寄件者: [REDACTED]
寄件日期: 2026年09月22日星期二 10:39
收件者: tpbpd/PLAND
副本: Belva Yuen King TONG/PLAND
主旨: A/YL-HTF/1207進一步資料
附件: HTF1207 GPRR R-to-C 31-8-2026.pdf; 排水建議計劃圖.pdf; 場地設計圖..pdf; A-YL-HTF-1207 GPRR 31-8-2026.pdf

**Project: Proposed Temporary Open Storage of
Construction Materials and Associated Filling of Land for
a Period of 3 Years at Lot 129 S.B (Part) in D.D. 128 and
Adjoining Government Land, Ha Tsuen, Yuen Long
(A/YL-HTF/1207)**

Geotechnical Planning Review Report

排水建議計劃圖

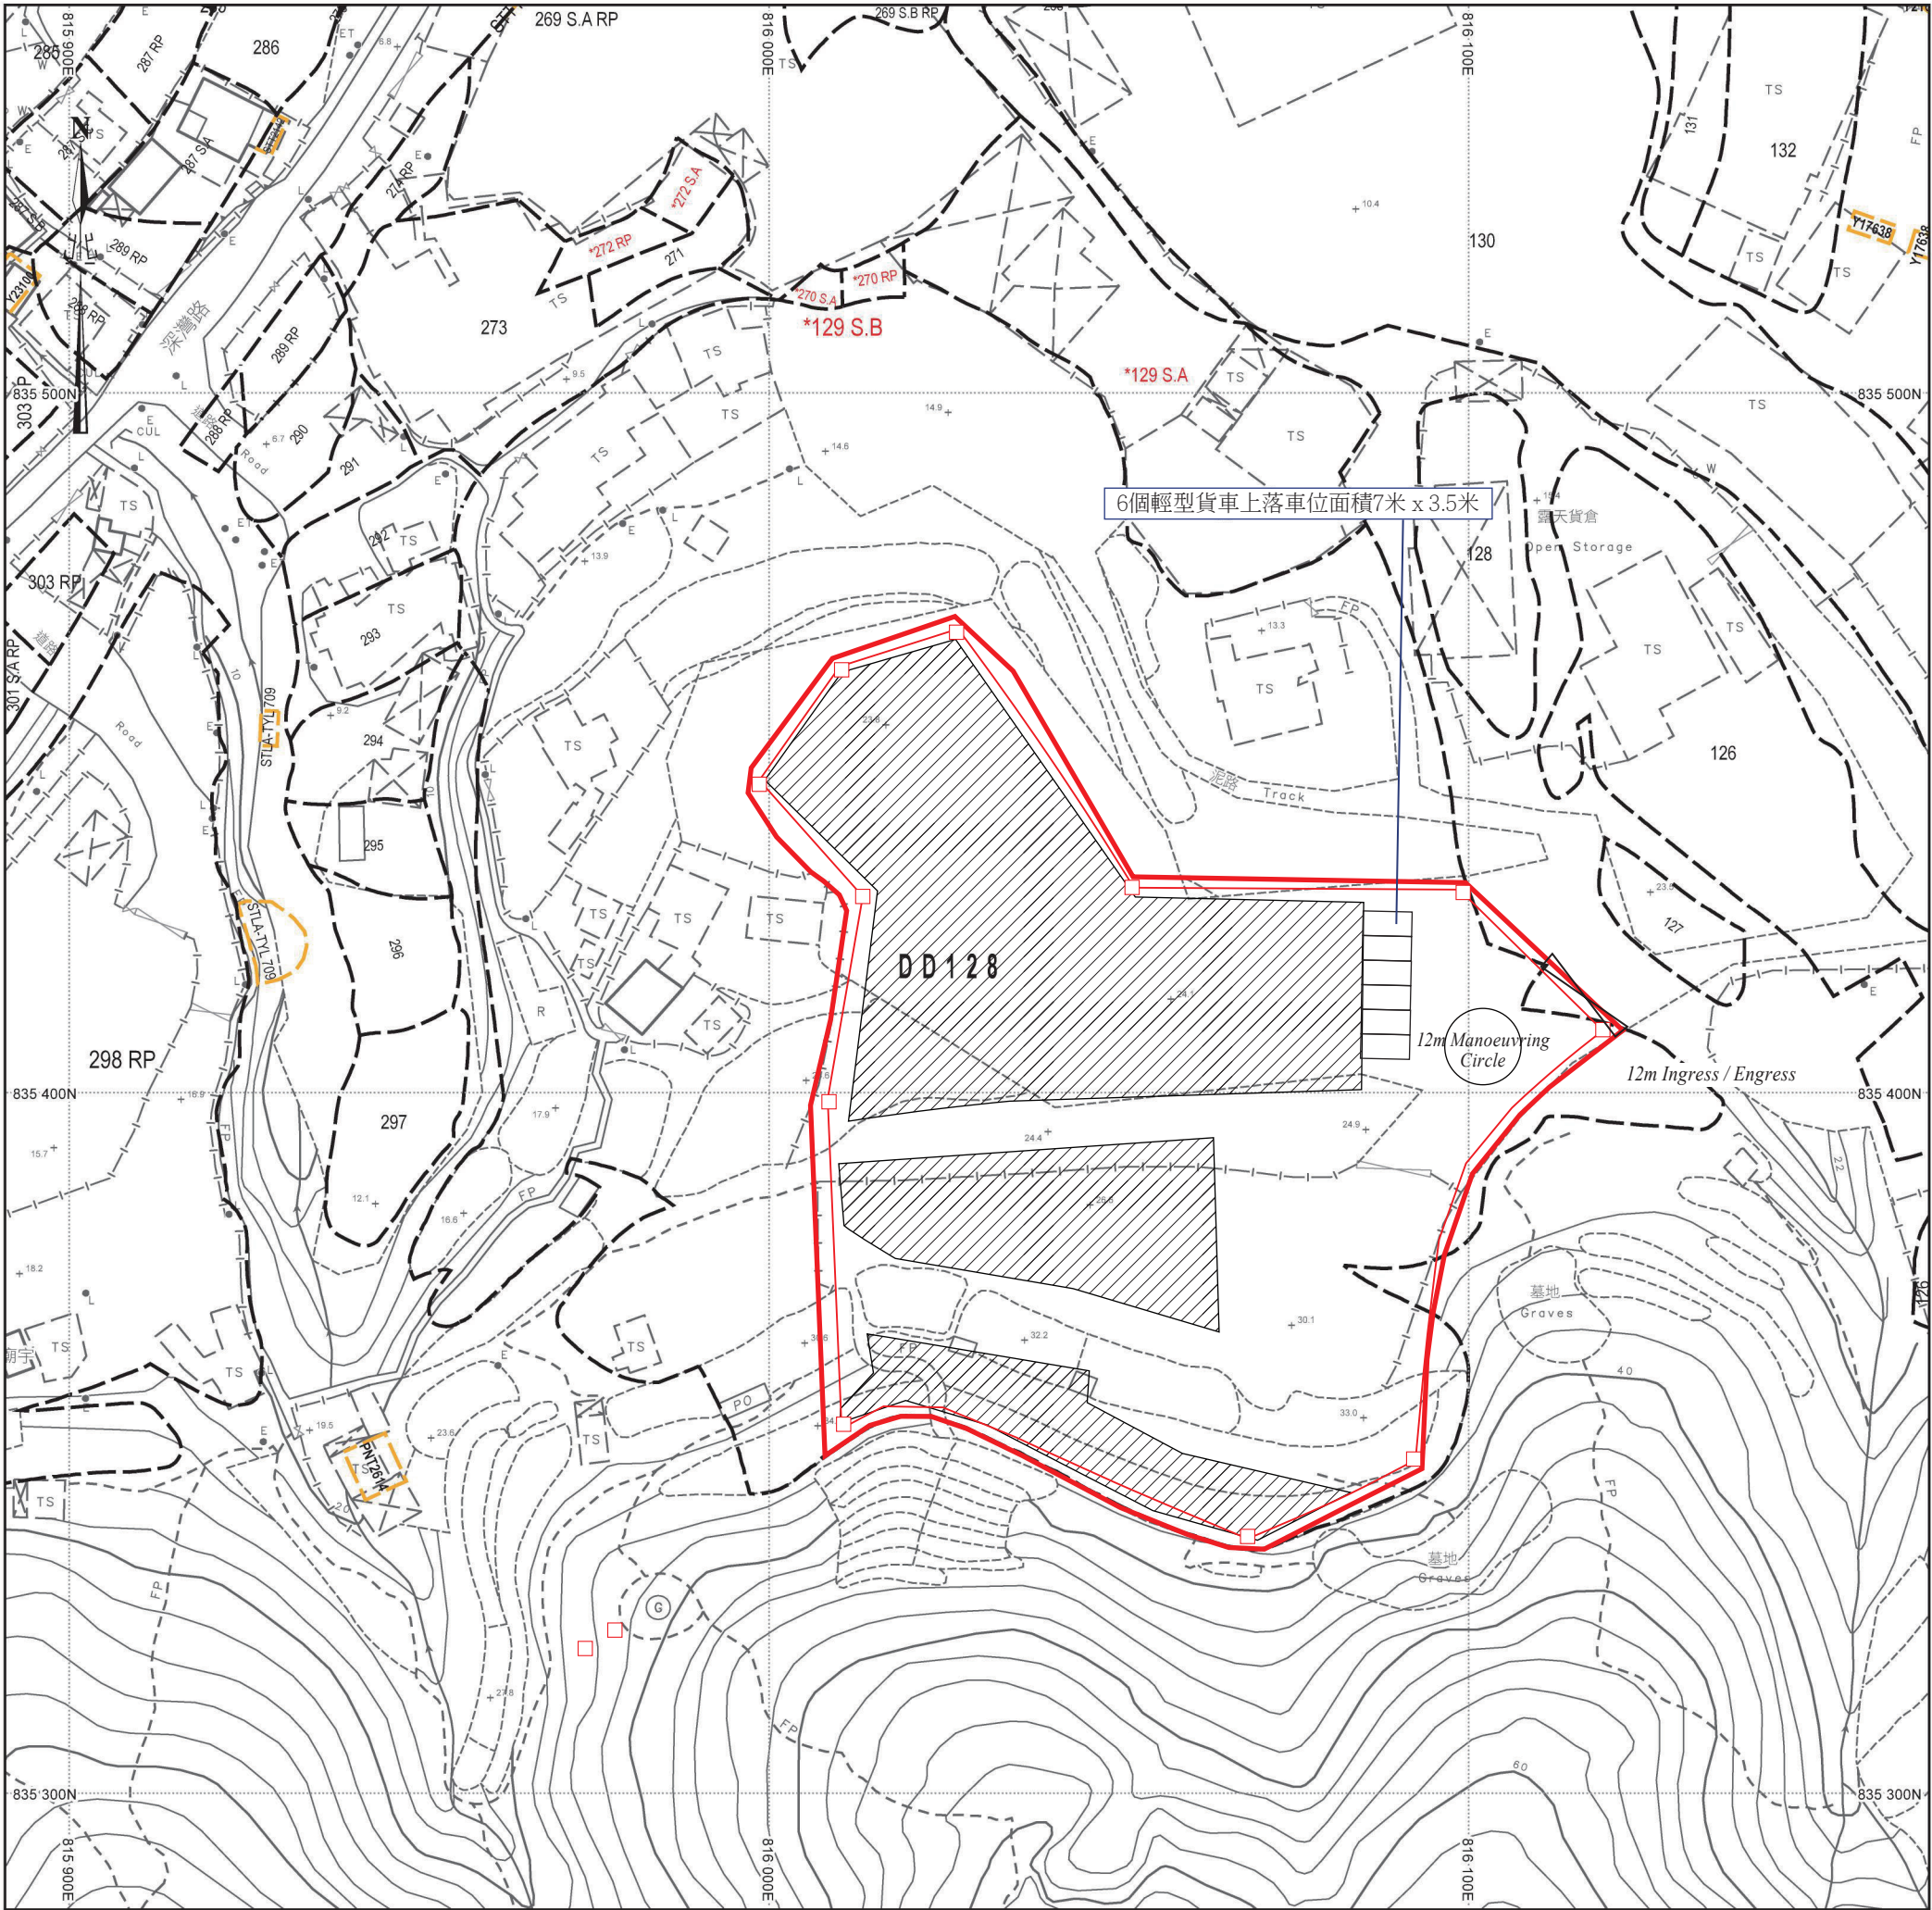
排水系統方面，場地會沿場地邊界（圍邊）鋪設，U 型渠的闊度及渠度約 375mm x 375mm，由於該場地先前已進行填土工程，整體地面已墊高約 0.2 米（200mm）。因此，本次排水渠施工只需於現有填土層額外向下挖掘約 175mm。挖掘工作完全局限於新增的填土層內，挖掘深度遠未觸及原始原生土層（，因此絕不會對現場及周邊之考古價值或地下文物造成任何影響，亦不會對周圍環境產生不良干擾。

Fig.3: Existing Feature Layout Plan

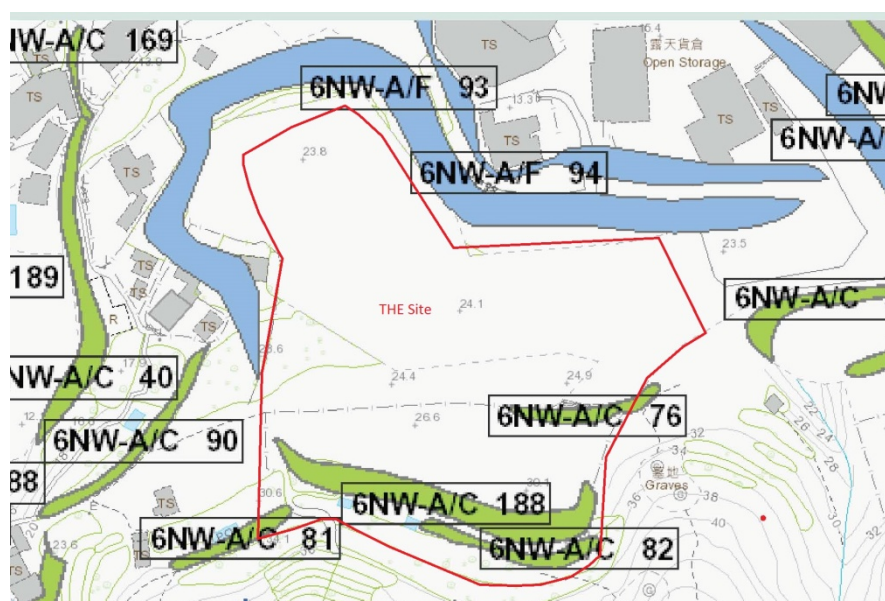
2. Section 2.4 of GPRR. The exact locations of all slope features listed in the GPRR should be indicated on a layout plan and the corresponding cross-sections.

All the slope features and the buffer zones are indicated on layout plan and sections.

Fig.4: Proposed Layout of the Development

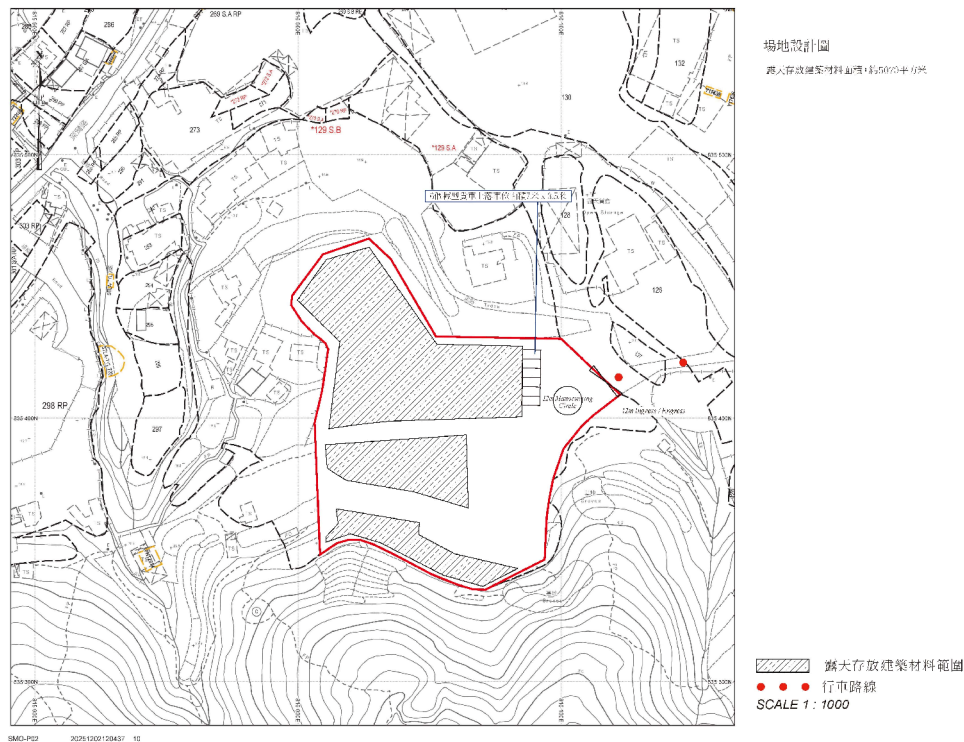
4. Section 3 and Figure 4 of GPRR. It is noted from Section 3 that there are car parking spaces in the non-occupation zone provided via our memo ref. PLN-50-2005-7-YL-HTF dated 3.3.2026, which contradicts to the applicant's response in Further Information (1) that there will be no car parking space in the southern side of the site. The applicant should clarify the nature of the loading and unloading areas marked on Figure 4. Natural Terrain Hazard Study (NTHS) is not required only if there are no critical facilities in the non-occupation zone.

Proposed layout of the application is revised. No carparking spaces within the buffer zones

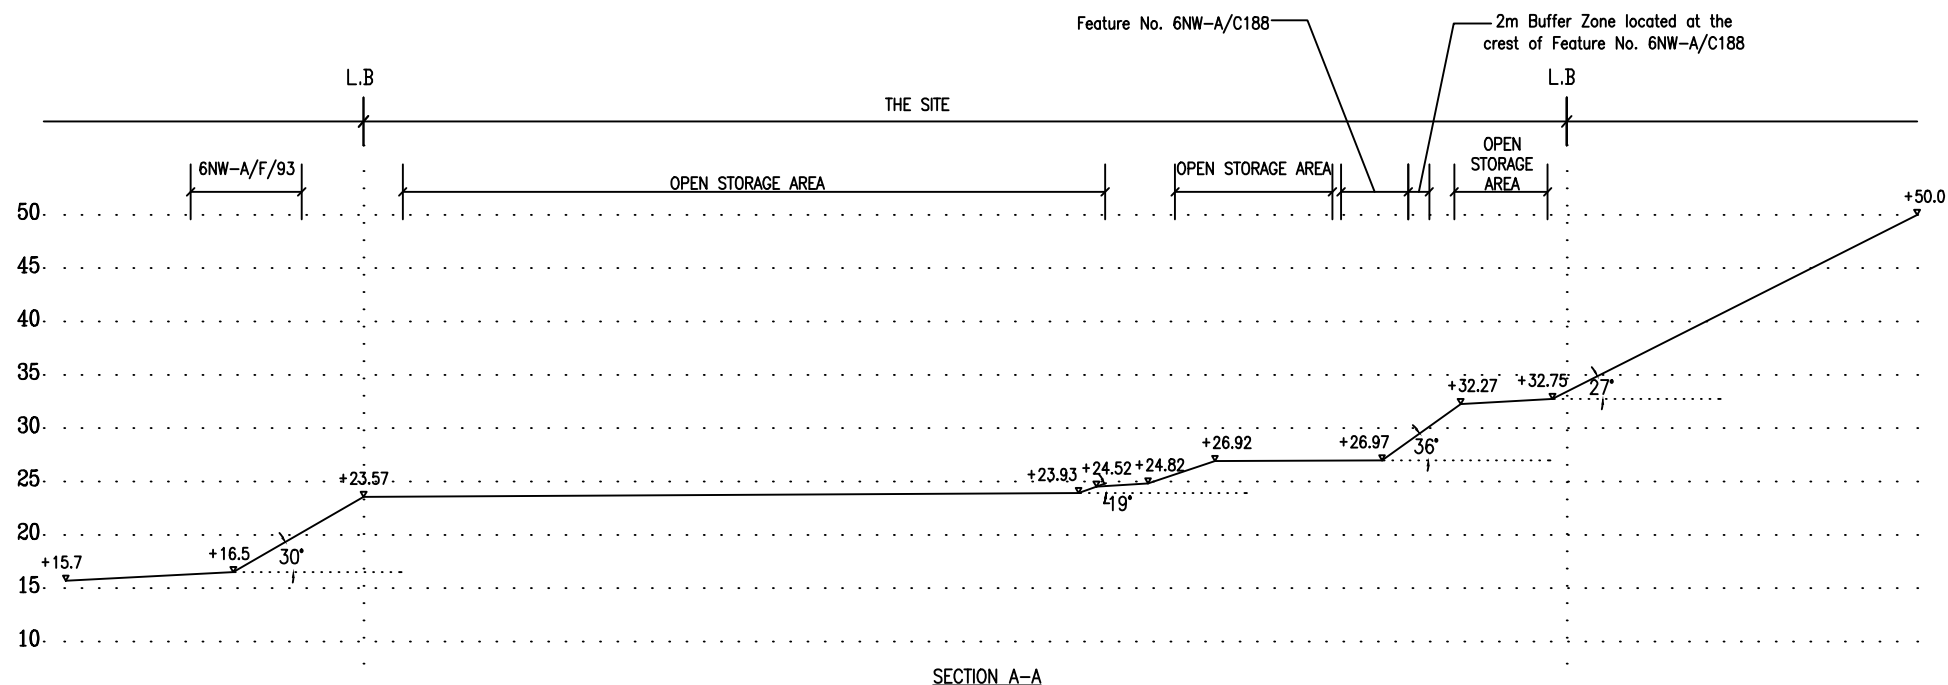
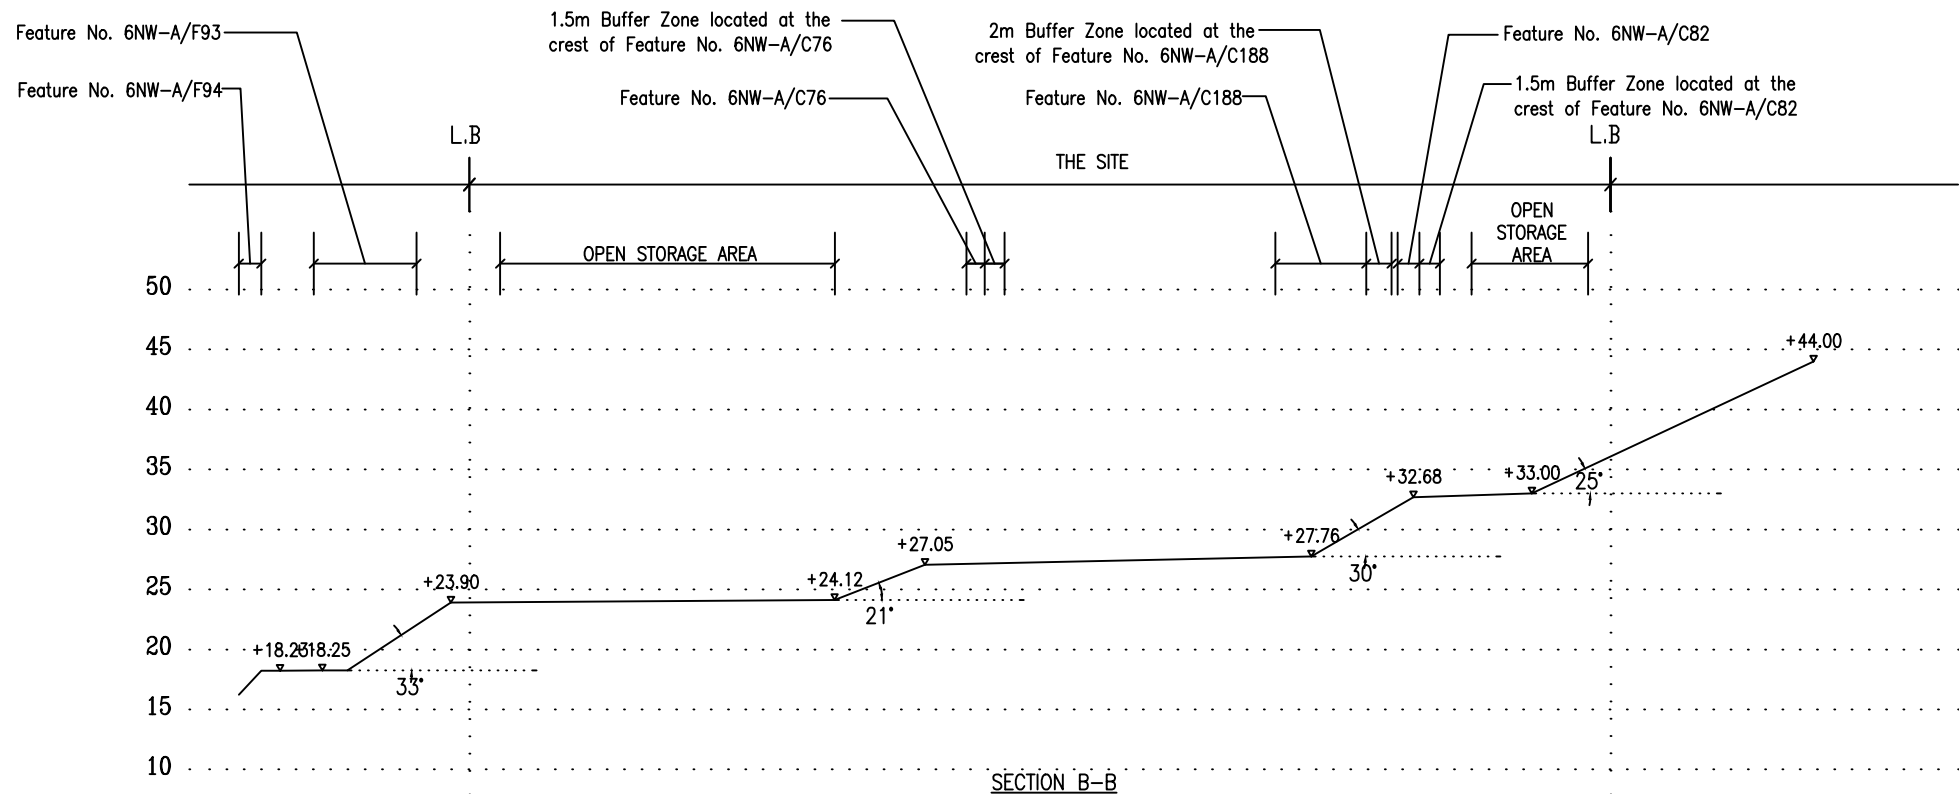
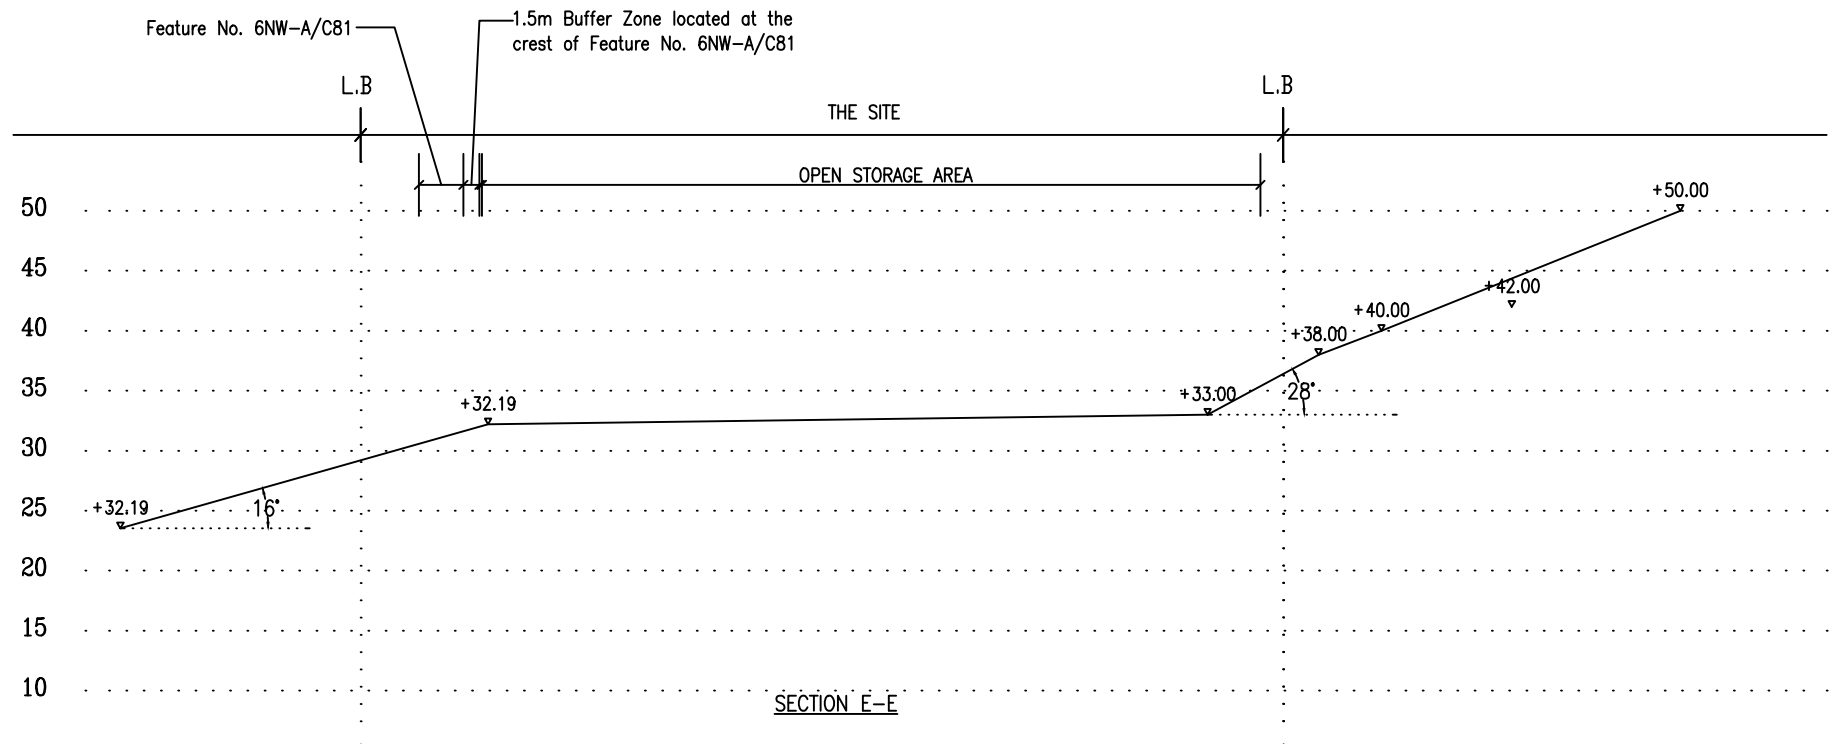
3. Section 3 of GPRR. It is noted that no structures are proposed on site. However, storage areas are illustrated at the slope crests as shown in Section A-A, B-B and E-E, which are within the buffer zone as proposed in our previous comments provided via memo ref. PLN-50-2005-7-YL-HTF dated 15.6.2026. The applicant should therefore demonstrate that the stability of the slopes would not affect or be affected by the proposed storage areas in the GPRR.

Proposed layout of the application is revised. No uses in the area within the buffer zones.
